J2126A-04A

S E R V I C E N O T E

J2126A AGILENT Transmission Test Set

Problems with ESD clips on the Clock and Electrical/Digital boards

Figure 1 Location of ESD Clips

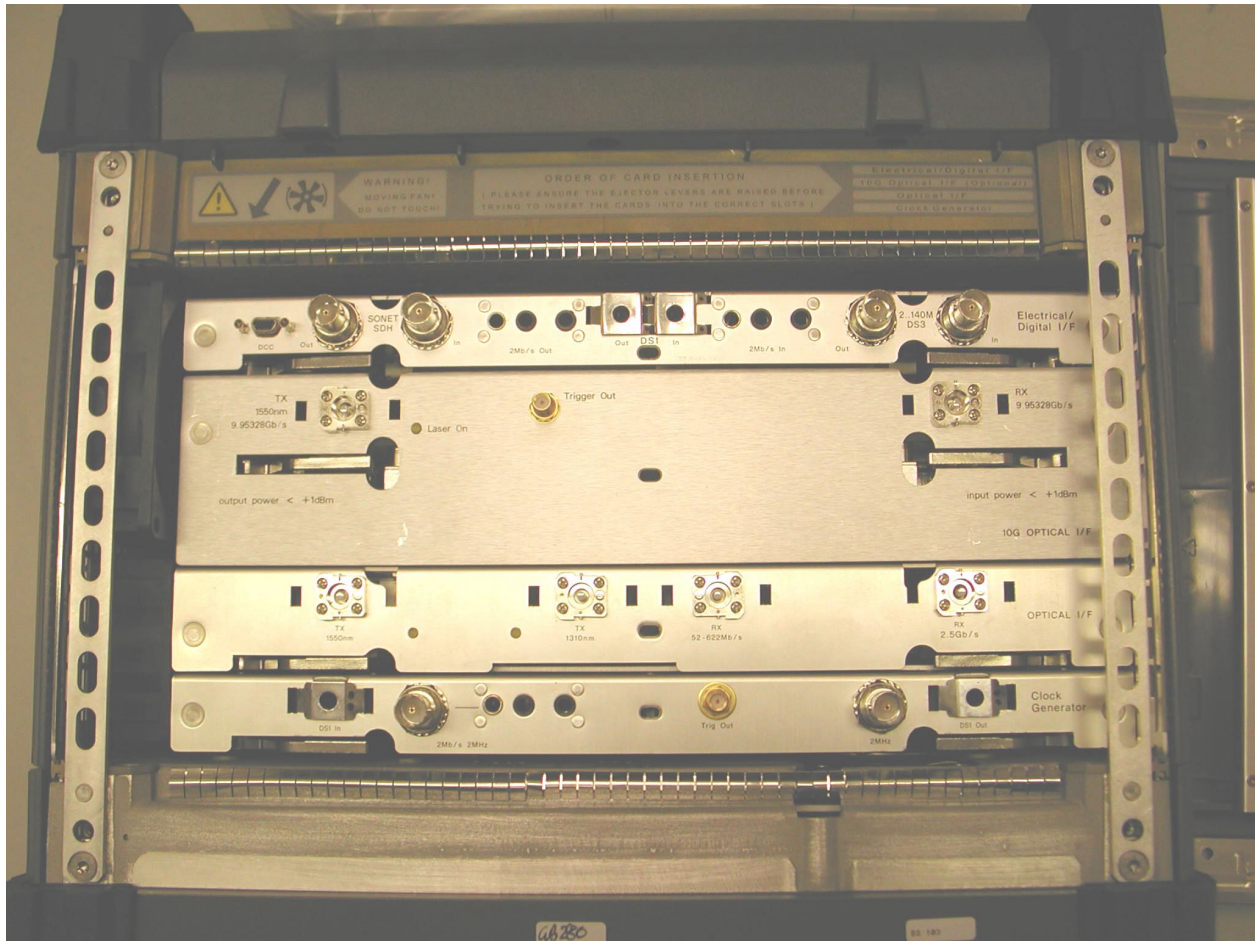
On early shipment of units we have experienced some problems when inserting or removing a bantam cable connector to the DS-1 ports on the Clock board and the Electrical/Digital board. The DS1 port on the boards are fitted with ESD clips and some instruments may be fitted with the wrong size clips. This causes the cable connector to scrape against the clips, leading to small metal scrapings falling into the instrument.

1. Unscrew the torque #15 screws at each corner of the top panel.
2. Remove the top panel.
3. Check that the ESD clips are properly aligned with the holes on the board panels.
4. Insert and remove the DS1 bantam cable into all of the ESD clips.
5. If the cable moves in and out smoothly, replace the top cover and retry.
6. If the cable still requires pressure to insert and remove, replace the clips using a suitable tool such as tweasers.

Note 1: To remove the clips, lever out one side first and then the other. To fit a new clip, fit one side of the clip first and then the other.

Note 2: When the clips are being replaced, the boards should be removed and the inside of the instrument inspected for any small pieces of metal scrapings. These should be removed before refitting the boards.
